AMERICANS WITH DISABILITY
ACT (ADA) FACILITY
ASSESSMENT REPORT

Americans with Disabilities Act (ADA) Facility Barrier Report

July 2024

North Gresham Park

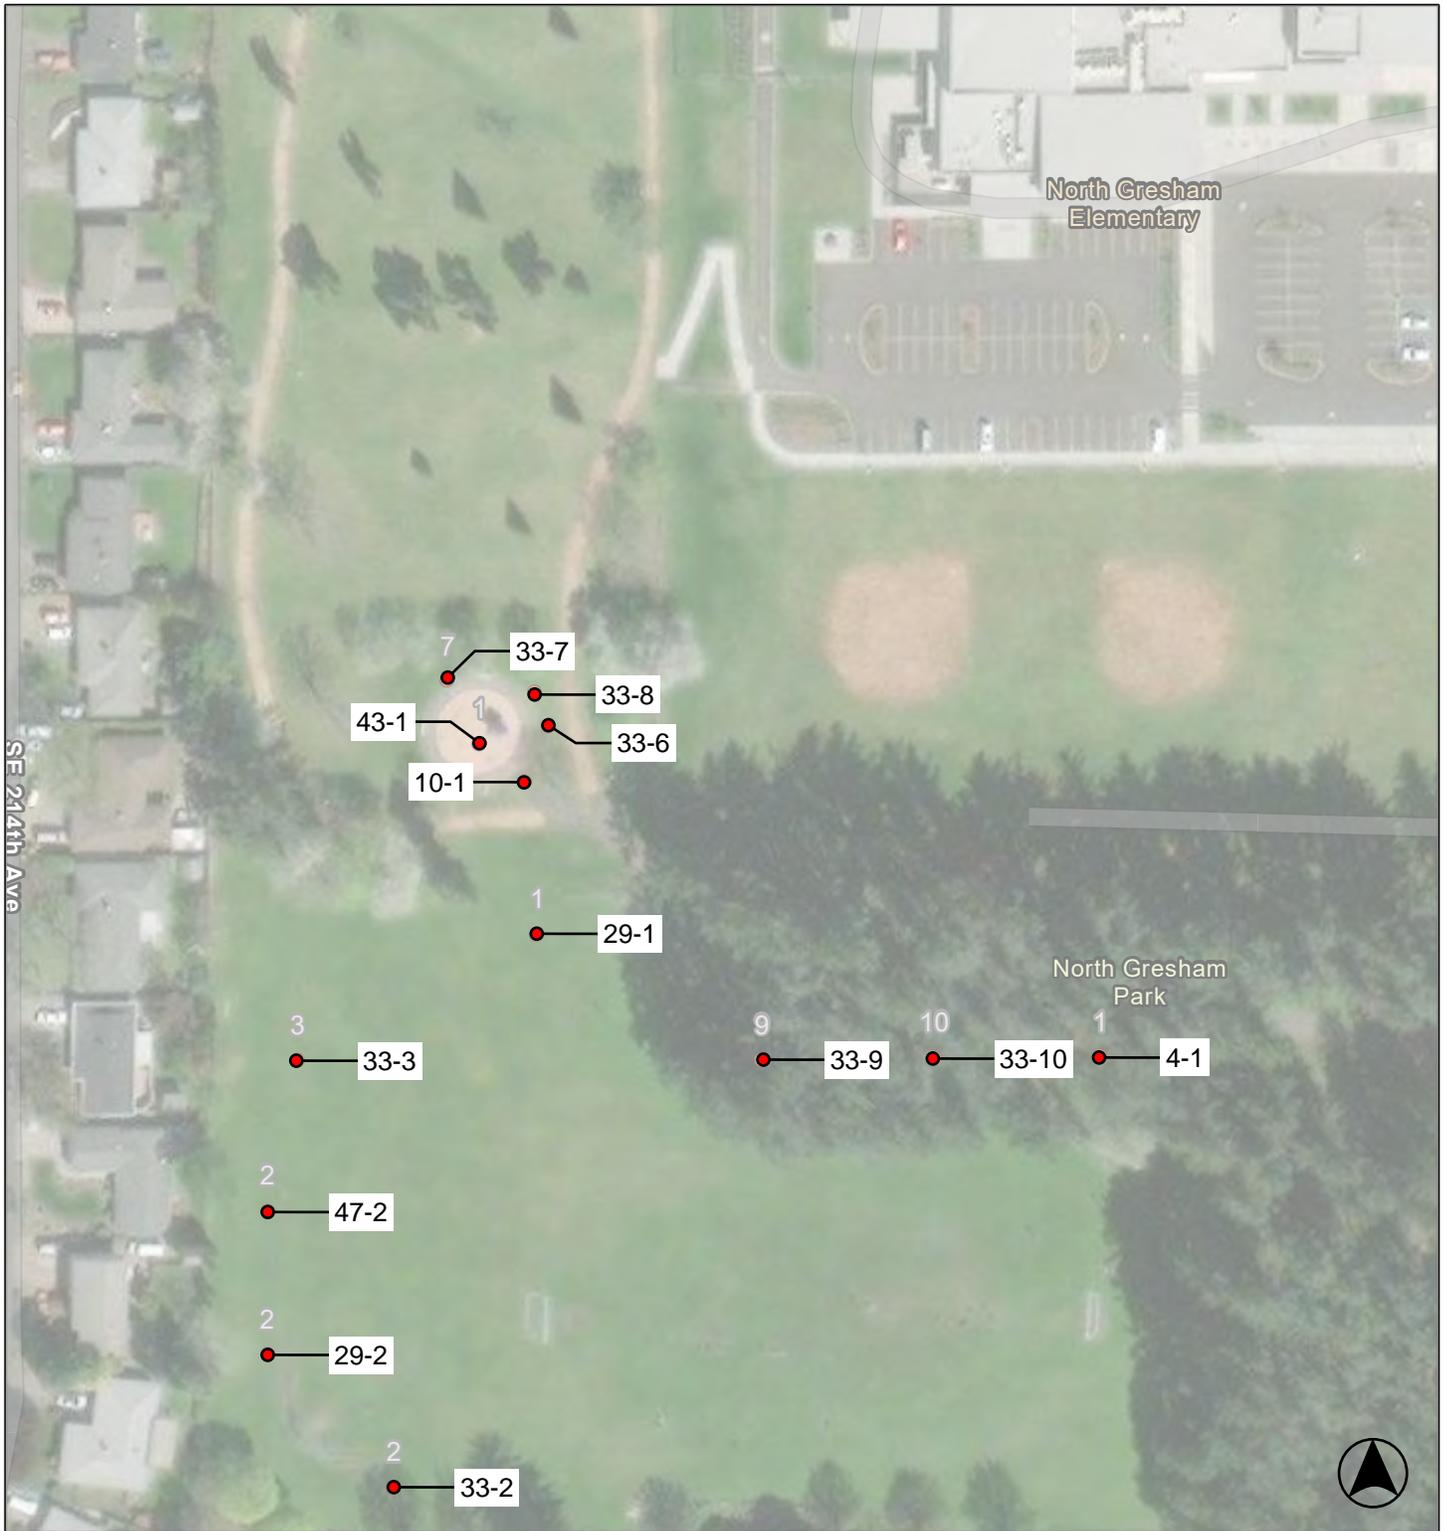
Park		
4 - 1	Walk	Category: 1
Provide an accessible route		\$55,600
Notes: An accessible route is not provided due to grass for 695 linear feet.		
ADA: 206.2.2		
Other: -		
4 - 2	Walk	Category: 1
Provide an accessible route		\$31,440
Notes: An accessible route is not provided from SE Salmon St. to the backstop for 393 linear feet.		
ADA: 206.2.2		
Other: -		
10 - 1	Drinking Fountain	Category: 3
Confirm water flow compliance		\$0
Notes: Water service to the drinking fountain was disconnected at the time of the assessment. Flow height and angle could not be confirmed.		
ADA: 602.3, 602.6		
Other: -		
29 - 1	Game and Sports Area	Category: 2
Provide wheelchair seating		\$3,600
Notes: No wheelchair spaces provided in team seating areas (two min - one per team space).		
ADA: 221.2.1.4		
Other: -		
Provide an accessible route		\$800
Notes: An accessible route to the baseball area is not provided. Route from path to the backstop is 10 linear feet over grass.

ADA: 206.2.2		
Other: -		
29 - 2	Game and Sports Area	Category: 2
Provide wheelchair seating		\$3,600
Notes: No wheelchair spaces provided in team seating areas (two min - one per team space). (x2)		
ADA: 221.2.1.4		
Other: -

Park	
33 - 1	Outdoor Constructed Features Category: 3
Increase or provide clear floor area	\$200
Notes: A clear ground space is not provided adjacent to the bench (36" by 48" min).	
ADA: -	
Other: ABA 1011.2.1, ABA 1011.2.3	
33 - 2	Outdoor Constructed Features Category: 3
Increase or provide clear floor area	\$200
Notes: A clear ground space is not provided adjacent to the bench (36" by 48" min).	
ADA: -	
Other: ABA 1011.2.1, ABA 1011.2.3	
33 - 3	Outdoor Constructed Features Category: 3
Increase or provide clear floor area	\$200
Notes: A clear ground space is not provided adjacent to the bench (36" by 48" min).	
ADA: -	
Other: ABA 1011.2.1, ABA 1011.2.3	
33 - 4	Outdoor Constructed Features Category: 3
Increase or provide clear floor area	\$200
Notes: A clear ground space is not provided adjacent to the bench (36" by 48" min).	
ADA: -	
Other: ABA 1011.2.1, ABA 1011.2.3	
33 - 5	Outdoor Constructed Features Category: 3

Increase or provide clear floor area	\$200
Notes: A clear ground space is not provided adjacent to the bench (36" by 48" min).	
ADA: -	
Other: ABA 1011.2.1, ABA 1011.2.3	
33 - 6	Outdoor Constructed Features Category: 3
Increase or provide clear floor area	\$200
Notes: A clear ground space is not provided adjacent to the bench (36" by 48" min).	
ADA: -	
Other: ABA 1011.2.1, ABA 1011.2.3	
33 - 7	Outdoor Constructed Features Category: 3
Increase or provide clear floor area	\$200
Notes: A clear ground space is not provided adjacent to the bench (36" by 48" min).	
ADA: -	
Other: ABA 1011.2.1, ABA 1011.2.3

Park	
33 - 8	Outdoor Constructed Features Category: 3
Increase or provide clear floor area	\$200
Notes: A clear ground space is not provided adjacent to the bench (36" by 48" min).	
ADA: -	
Other: ABA 1011.2.1, ABA 1011.2.3	
33 - 9	Outdoor Constructed Features Category: 3
Increase or provide clear floor area	\$200
Notes: A clear ground space is not provided adjacent to the bench (36" by 48" min).	
ADA: -	
Other: ABA 1011.2.1, ABA 1011.2.3	
33 - 10	Outdoor Constructed Features Category: 3
Increase or provide clear floor area	\$200
Notes: A clear ground space is not provided adjacent to the bench (36" by 48" min).	
ADA: -	
Other: ABA 1011.2.1, ABA 1011.2.3	
43 - 1	Play Equipment Area Category: 2
Improve or evaluate play area surface	\$0
Notes: Ground surface in play area is in need of maintenance and further evaluation of fall attenuation surface is recommended.	
ADA: 1008.2.6.1, 1008.2.6.2	
Other: -	
Regrade or replace ramp	\$540

Notes: The ramp into the play area has a 10% slope (8.33% max).	
ADA: 240.2.1	
Other: -	
47 - 1	Trails Category: 2
Provide a firm, stable and slip resistant surface	\$80,720
Notes: The trail surface is not firm and stable. Trail surface is loose woodchips for 2018 linear feet.	
ADA: -	
Other: ABA 1017.2	
Install sign	\$250
Notes: A trail sign is not provided.	
ADA: -	
Other: ABA 1017.10

Park	
47 - 2	Trails Category: 2
Provide a firm, stable and slip resistant surface	\$15,520
Notes: The trail surface is not firm and stable. Trail surface is grass and dirt for 388 linear feet.	
ADA: -	
Other: ABA 1017.2	
Install sign	\$250
Notes: A trail sign is not provided.	
ADA: -	
Other: ABA 1017.10	
47 - 3	Trails Category: 2
Provide a firm, stable and slip resistant surface	\$26,880
Notes: The trail surface is not firm and stable. Trail surface is grass and dirt for 672 linear feet. Trail is implied along the South edge of filed with benches, connects to adjacent right-of-way.	
ADA: -	
Other: ABA 1017.2	
Install sign	\$250
Notes: A trail sign is not provided.	
ADA: -	
Other: ABA 1017.10

Pat Pfeifer Park

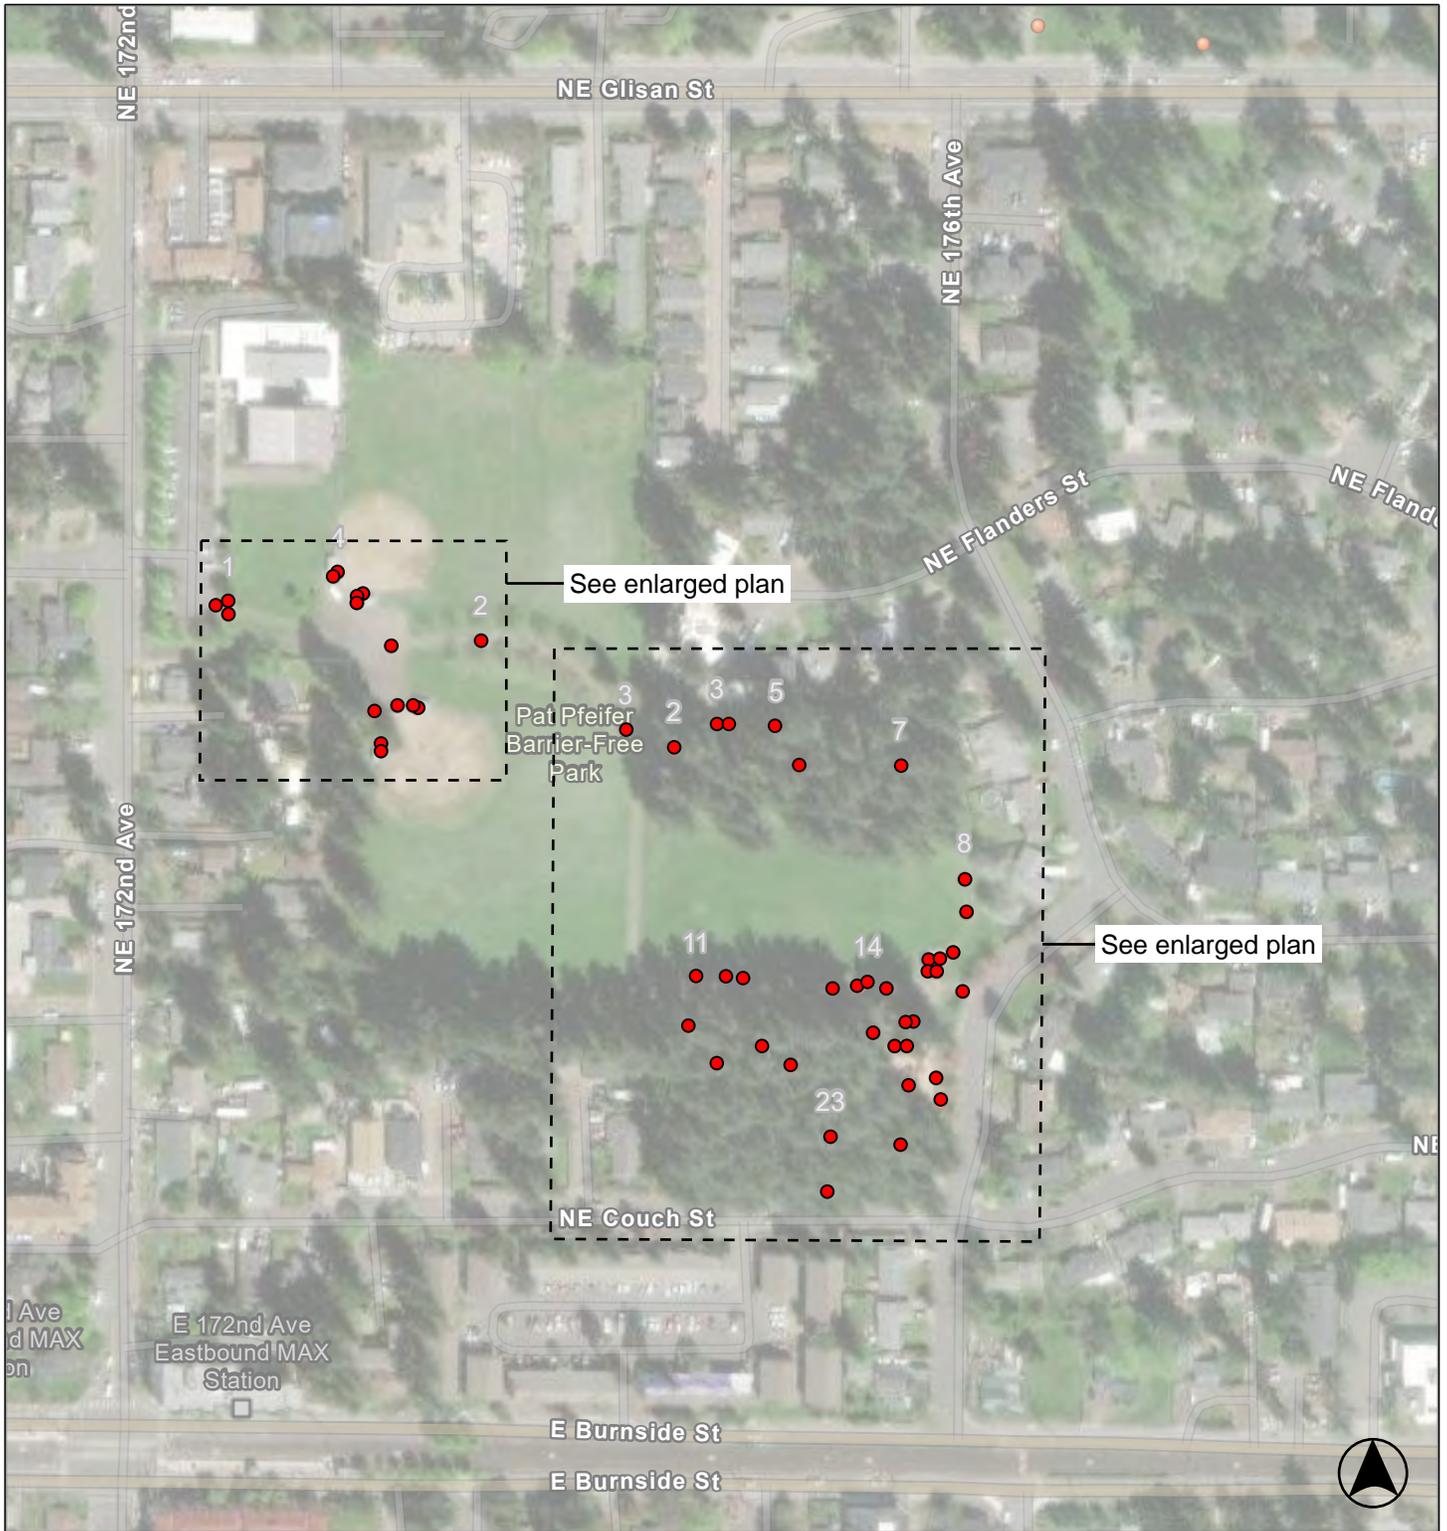
Park		
1 - 1	Parking Area	Category: 1
Regrade accessible parking space or access aisle		\$4,050
Notes: Slopes of accessible parking space and access aisle are up to 6.2% (2.0% max).		
ADA: 502.4		
Other: -		
Provide adequate striping		\$180
Notes: The words "No Parking" are not painted in the access aisle.		
ADA: -		
Other: OSSC 1106.7		
Reduce or eliminate opening		\$300
Notes: Surface of parking area has opening greater than 1/2" due to stormwater drain grate (Max 1/2" openings permitted).		
ADA: 302.3		
Other: -		
Install van accessible sign		\$1,750
Notes: A "Van Accessible" sign is not provided ("Van Accessible" sign that is 18" wide by 9" high on a white retroreflective background and green retroreflective lettering provided at each van accessible space).		
ADA: 208.2.4, 502.6		
Other: OSSC 1106.7		
Provide a pavement stencil		\$310
Notes: Paint is not retroreflective and is fading.		
ADA: -		
Other: OSSC 1106.7

Park		
4 - 2	Walk	Category: 1
Regrade surface		\$2,800
Notes: Cross slope of concrete path is up to 5.2% for 28 linear feet (2.0% max).		
ADA: 403.3		
Other: -		
4 - 3	Walk	Category: 1
Grind or patch vertical change of grade		\$100
Notes: Surface level change is 1/2" due to loose bricks (1/4" max; up to 1/2" with a 1:2 bevel).		
ADA: 303.2, 303.3		
Other: -		
4 - 4	Walk	Category: 1
Regrade surface		\$4,000
Notes: Cross slope of concrete path is up to 4.5% for 40 linear feet (2.0% max).		
ADA: 403.3		
Other: -		
4 - 5	Walk	Category: 1
Grind or patch vertical change of grade		\$100
Notes: Surface level change is 1/2" due to loose bricks (1/4" max; up to 1/2" with a 1:2 bevel).		
ADA: 303.2, 303.3		
Other: -		
4 - 6	Walk	Category: 1
Grind or patch vertical change of grade		\$100
Notes: Surface level change is 1/2" due to loose bricks (1/4" max; up to 1/2" with a 1:2 bevel).		
ADA: 303.2, 303.3		
Other: -		
4 - 7	Walk	Category: 1

Grind or patch vertical change of grade		\$100
Notes: Surface level change is 1/2" due to loose bricks (1/4" max; up to 1/2" with a 1:2 bevel).		
ADA: 303.2, 303.3		
Other: -

Park		
4 - 12	Walk	Category: 1
Regrade surface		\$25,200
Notes: Running slope of concrete is up to 10.8% for 12 linear feet (5.0% max).		
Cross slope of concrete is up to 7.5% for 240 linear feet (2.0% max).		
ADA: 403.3		
Other: -		
Grind or patch vertical change of grade		\$500
Notes: Surface level change is 3/4" at concrete joint (1/4" max; up to 1/2" with a 1:2 bevel). (x5)		
ADA: 303.2, 303.3		
Other: -		
Reduce or eliminate opening		\$900
Notes: Gap at concrete joint is 1-1/2" (1/2" max).(x3)		
ADA: 302.3		
Other: -		
8 - 1	Door/Gate	Category: 1
Provide or modify door kick plate		\$350
Notes: A smooth and uninterrupted kick plate surface is not provided. Chain-link is located in the 10" space above the finish floor.		
ADA: 404.2.10		
Other: -		
Increase or provide clear floor space		\$1,270
Notes: An exterior landing is not provided at the gate (30" by 48" min).		
ADA: 305.2, 305.3, 305.5		
Other: -		
8 - 2	Door/Gate	Category: 1

Provide or modify door kick plate		\$350
Notes: A smooth and uninterrupted kick plate surface is not provided. Chain-link is located in the 10" space above the finish floor.		
ADA: 404.2.10		
Other: -		
Increase or provide clear floor space		\$1,270
Notes: An exterior landing is not provided at the gate (30" by 48" min).		
ADA: 305.2, 305.3, 305.5		
Other: -

Park	
8 - 3	Door/Gate Category: 1
Provide or modify door kick plate	\$350
Notes: A smooth and uninterrupted kick plate surface is not provided. Chain-link is located in the 10" space above the finish floor.	
ADA: 404.2.10	
Other: -	
Replace or modify door threshold	\$160
Notes:	
ADA: 404.2.5	
Other: -	
8 - 4	Door/Gate Category: 1
Provide or modify door kick plate	\$350
Notes: A smooth and uninterrupted kick plate surface is not provided. Chain-link is located in the 10" space above the finish floor.	
ADA: 404.2.10	
Other: -	
Replace or modify door threshold	\$160
Notes: Transition onto ballfield surface has a vertical drop greater than 1/2" (max 1/4" vertical or 1/2" with 1:2 bevel).	
ADA: 404.2.5	
Other: -	
8 - 5	Door/Gate Category: 1
Provide or modify door kick plate	\$350
Notes: A smooth and uninterrupted kick plate surface is not provided. Chain-link is located in the 10" space above the finish floor.	
ADA: 404.2.10

Other: -	
Increase or provide clear floor space	\$1,270
Notes: An exterior landing is not provided at the gate (30" by 48" min).	
ADA: 305.2, 305.3, 305.5	
Other: -

Park	
8 - 6	Door/Gate Category: 1
Provide or modify door kick plate	\$350
Notes: A smooth and uninterrupted kick plate surface is not provided. Chain-link is located in the 10" space above the finish floor.	
ADA: 404.2.10	
Other: -	
Replace or modify door threshold	\$160
Notes: Transition onto ballfield surface has a vertical drop greater than 1/2" (max 1/4" vertical or 1/2" with 1:2 bevel).	
ADA: 404.2.5	
Other: -	
8 - 7	Door/Gate Category: 1
Provide or modify door kick plate	\$350
Notes: A smooth and uninterrupted kick plate surface is not provided. Chain-link is located in the 10" space above the finish floor.	
ADA: 404.2.10	
Other: -	
Increase or provide clear floor space	\$1,270
Notes: An exterior landing is not provided at the gate (30" by 48" min).	
ADA: 305.2, 305.3, 305.5	
Other: -	
8 - 8	Door/Gate Category: 1
Provide or modify door kick plate	\$350
Notes: A smooth and uninterrupted kick plate surface is not provided. Chain-link is located in the 10" space above the finish floor.

ADA: 404.2.10	
Other: -	
Replace or modify door threshold	\$160
Notes: Transition onto ballfield surface has a vertical drop greater than 1/2" (max 1/4" vertical or 1/2" with 1:2 bevel).	
ADA: 404.2.5	
Other: -

Park	
8 - 9	Door/Gate Category: 1
Replace or modify door threshold	\$160
Notes: Threshold is not beveled (1/4" max; up to 1/2" with a 1:2 bevel).	
ADA: 404.2.5	
Other: -	
Adjust door closer	\$160
Notes: Door closer sweep time is less than the five second minimum from 90 degrees to 12 degrees.	
Door opening force is 6 lbs (5 lbs max).	
ADA: 404.2.8.1, 404.2.9	
Other: OSSC 1102.1.2.5	
Regrade surface	\$625
Notes: Slope of the exterior landing is 5.6% (2.0% max).	
ADA: 404.2.4.4	
Other: -	
8 - 10	Door/Gate Category: 1
Adjust door closer	\$160
Notes: Door closer sweep time is less than the five second minimum from 90 degrees to 12 degrees.	
ADA: 404.2.8.1	
Other: -	
Regrade surface	\$625
Notes: Slope of the exterior landing is 9.1% (2.0% max).	
ADA: 404.2.4.4	
Other: -	
10 - 1	Drinking Fountain Category: 3
Confirm water flow compliance	\$0
Notes: Water service to the drinking fountain was disconnected at the time of the assessment. Flow height and angle could not be confirmed.

Park	
20 - 1	Single User Restroom Category: 2
Install restroom sign	\$250
Notes: Replace sign - the tactile elements are broken, the braille is not located beneath the letters. The word "restroom" is not tactile.	
ADA: 216.8	
Other: -	
Replace or reposition mirror	\$160
Notes: Bottom of the mirror's reflecting surface above the lavatory is 40-1/4" AFF (40" max).	
ADA: 603.3	
Other: -	
Increase water closet clear width or depth	\$840
Notes: Clear width over water closet is 59" (60" min) to the side wall.	
ADA: 604.3.1, 604.8.1	
Other: -	
Replace or reposition fixtures	\$1,590
Notes: The water closet centerline is 18-1/2" from the wall (16" min to 18" max).	
ADA: 604.2	
Other: -	
Modify operating mechanism	\$320
Notes: Operating effort of the soap dispenser is 6 lbs (5 lbs max).	
ADA: 309.4	
Other: -	
Confirm water flow compliance	\$0
Notes: Water service to the lavatory was disconnected at the time of the assessment. Force to operate and water metering could not be confirmed.

Park	
20 - 2	Single User Restroom Category: 2
Install restroom sign	\$250
Notes: Replace sign - the tactile elements are broken, the braille is not located beneath the letters. The word "restroom" is not tactile.	
ADA: 216.8	
Other: -	
Modify operating mechanism	\$640
Notes: Operating effort of soap dispenser is 8 lbs (5 lbs max).	
ADA: 309.4	
Other: -	
Replace or reposition fixtures	\$1,590
Notes: The water closet centerline is 18-1/2" from the wall (16" min to 18" max).	
ADA: 604.2	
Other: -	
Replace or adjust water controls	\$640
Notes: Operating effort of lavatory faucet is 6 lbs (5 lbs max).	
ADA: 309.4, 606.4	
Other: -	
29 - 1	Game and Sports Area Category: 2
Provide an accessible route	\$3,200
Notes: An accessible route to the baseball area is not provided. Route from the path to the baseball is 40 linear feet over grass.	
ADA: 206.2.2	
Other: -	
Provide wheelchair seating	\$1,800
Notes: Wheelchair seating is not provided. (2 wheelchair spaces min for 40 seats).

ADA: 221.2.1.1	
Other: -	
29 - 2	Game and Sports Area Category: 2
Provide an accessible route	\$3,200
Notes: An accessible route to the baseball area is not provided. Route from the path to the baseball is 40 linear feet over grass.	
ADA: 206.2.2	
Other: -	
Provide wheelchair seating	\$1,800
Notes: Wheelchair seating is not provided. (2 wheelchair spaces min for 40 seats).	
ADA: 221.2.1.1	
Other: -

Park	
33 - 2	Outdoor Constructed Features Category: 3
Increase or provide clear floor area	\$600
Notes: A clear ground space is not provided adjacent to the bench (36" by 48" min). (x3)	
ADA: -	
Other: ABA 1011.2.1, ABA 1011.2.3	
33 - 3	Outdoor Constructed Features Category: 3
Increase or provide clear floor area	\$200
Notes: A clear floor space is not provided at the trash container opening (36" by 60" min parallel approach or 36" by 48" min forward approach). Container is 42" from the path.	
ADA: -	
Other: ABA 1011.2	
33 - 4	Outdoor Constructed Features Category: 3
Increase or provide clear floor area	\$400
Notes: A clear ground space is not provided adjacent to the bench (36" by 48" min). (x2)	
ADA: -	
Other: ABA 1011.2.1, ABA 1011.2.3	
33 - 5	Outdoor Constructed Features Category: 3
Increase or provide clear floor area	\$200
Notes: A clear floor space is not provided at the trash container opening (36" by 60" min parallel approach or 36" by 48" min forward approach). Container is 40" from the path.

ADA: -	
Other: ABA 1011.2	
33 - 6	Outdoor Constructed Features Category: 3
Increase or provide clear floor area	\$200
Notes: Clear ground space adjacent to the trash can has a slope of 7.4% (2.0% max).	
ADA: -	
Other: ABA 1011.2	
33 - 7	Outdoor Constructed Features Category: 3
Increase or provide clear floor area	\$200
Notes: A clear floor space is not provided at the trash container opening (36" by 60" min parallel approach or 36" by 48" min forward approach). Broken and uneven pavement in the clear floor space.	
ADA: -	
Other: ABA 1011.2.1, ABA 1011.2.3

Park	
33 - 8	Outdoor Constructed Features Category: 3
Increase or provide clear floor area	\$200
Notes: A clear ground space is not provided adjacent to the bench (36" by 48" min). The surface is gravel.	
ADA: -	
Other: ABA 1011.2.1, ABA 1011.2.3	
33 - 9	Outdoor Constructed Features Category: 3
Increase or provide clear floor area	\$200
Notes: A clear ground space is not provided adjacent to the bench (36" by 48" min).	
ADA: -	
Other: ABA 1011.2.1, ABA 1011.2.3	
33 - 10	Outdoor Constructed Features Category: 3
Increase or provide clear floor area	\$200
Notes: A clear floor space is not provided at the trash container opening (36" by 60" min parallel approach or 36" by 48" min forward approach). Container is 37" from the path.	
ADA: -	
Other: ABA 1011.2	
33 - 11	Outdoor Constructed Features Category: 3
Increase or provide clear floor area	\$200
Notes: A clear floor space is not provided at the trash container opening (36" by 60" min parallel approach or 36" by 48" min forward approach). Container is 42" from the path.

ADA: -	
Other: ABA 1011.2	
35 - 1	Other Category: 3
Increase or provide maneuvering or clear floor area	\$200
Notes: Slope of the dog bag station clear floor space is 3.1% (2.0% max).Pavers are loose and uneven.	
ADA: 305.2, 305.3, 305.5	
Other: -

Park	
47 - 1 Trails	Category: 2
Regrade surface	\$840
Notes: Cross slope of path is up to 3.9% for 14 linear feet (2.0% max).	
ADA: -	
Other: ABA 1017.7.2	
Install sign	\$250
Notes: Provide trail sign including length of the trail or trail segment, surface type, typical an dminimum tread width, typical and maximum running slope, and typical and maximum cross slope.	
ADA: -	
Other: ABA 1017.10	
47 - 2 Trails	Category: 2
Regrade surface	\$600
Notes: Cross slope of path is up to 4.0% for 10 linear feet (2.0% max).	
ADA: -	
Other: ABA 1017.7.2	
47 - 3 Trails	Category: 2
Regrade surface	\$600
Notes: Cross slope of path is up to 3.8% for 10 linear feet (2.0% max).	
ADA: -	
Other: ABA 1017.7.2	
Reduce or eliminate opening	\$300
Notes: Gap at crack in surface is greater than 1/2" (1/2" max).	
ADA: 302.3	
Other: ABA 1017.6	
47 - 4 Trails	Category: 2
Regrade surface	\$2,280
Notes: Cross slope of path is up to 3.8% for 38 linear feet (2.0% max).

Park	
47 - 9 Trails	Category: 2
Regrade surface	\$300
Notes: Run slope of path is up to 13.0% for 5 linear feet (12.0% max).	
ADA: -	
Other: ABA 1017.7.1	
Install sign	\$250
Notes: Provide trail sign including length of the trail or trail segment, surface type, typical and minimum tread width, typical and maximum running slope, and typical and maximum cross slope.	
ADA: -	
Other: ABA 1017.10	
47 - 10 Trails	Category: 2
Regrade surface	\$2,940
Notes: Cross slope of path is up to 5.0% for 49 linear feet (2.0% max).	
ADA: -	
Other: ABA 1017.7.2	
Reduce or eliminate opening	\$300
Notes: Gap at cracks is greater than 1/2" (1/2" max).	
ADA: 302.3	
Other: ABA 1017.6	
47 - 11 Trails	Category: 2
Regrade surface	\$2,400
Notes: Cross slope of path is up to 9.9% for 37 linear feet (2.0% max).	
ADA: -	
Other: ABA 1017.7.2	
47 - 12 Trails	Category: 2
Regrade surface	\$3,840
Notes: Cross slope of path is up to 8.5% for 64 linear feet (2.0% max).

ADA: -	
Other: ABA 1017.7.2	
Install sign	\$250
Notes: Provide trail sign including length of the trail or trail segment, surface type, typical and minimum tread width, typical and maximum running slope, and typical and maximum cross slope.	
ADA: -	
Other: ABA 1017.10

Park	
47 - 13 Trails	Category: 2
Regrade surface	\$2,520
Notes: Cross slope of path is up to 4.2% for 42 linear feet (2.0% max).	
ADA: -	
Other: ABA 1017.7.2	
47 - 14 Trails	Category: 2
Regrade surface	\$1,140
Notes: Cross slope of path is up to 7.6% for 19 linear feet (2.0% max).	
ADA: -	
Other: ABA 1017.7.2
